**STATE OF DELAWARE  
EXECUTIVE DEPARTMENT  
OFFICE OF STATE PLANNING COORDINATION**

RE: PLUS review – 2010-08-01- Capital School District/New Dover High School

According to the information received, you are seeking site plan approval through the City of Dover for a 235,000 sq. ft. high school and sports fields on 102 acres.

Figure 1: Soil mapping in the immediate vicinity of the proposed project

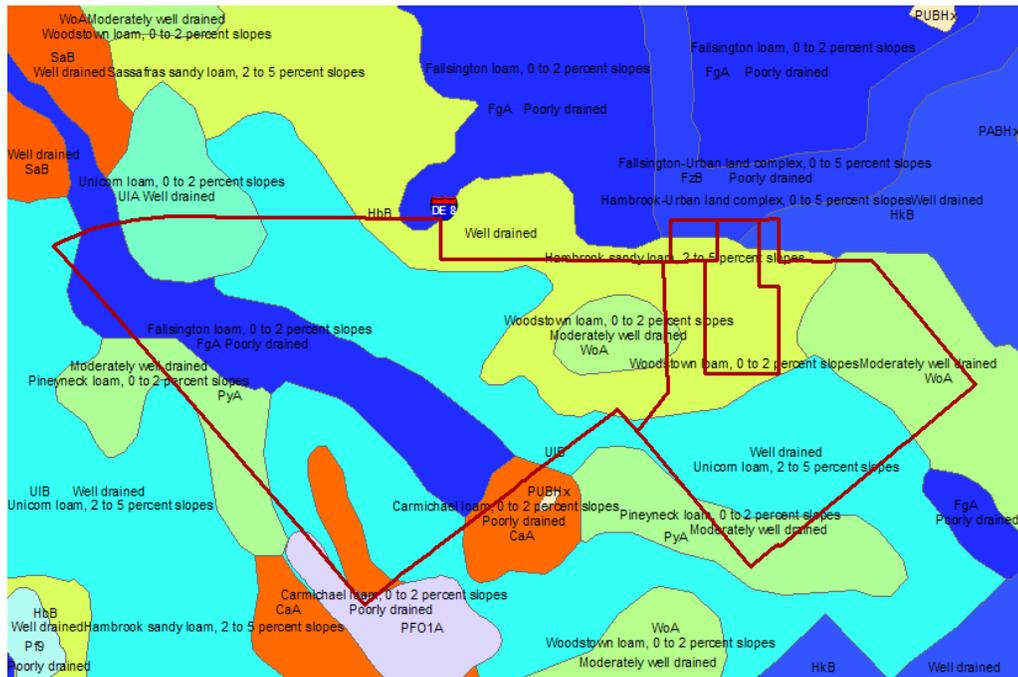
- **Soils Assessment.** DNREC suggests the applicant avoid the area containing the poorly-drained wetland associated (hydric) Fallsington soil mapping unit (FgA; see figure 1).
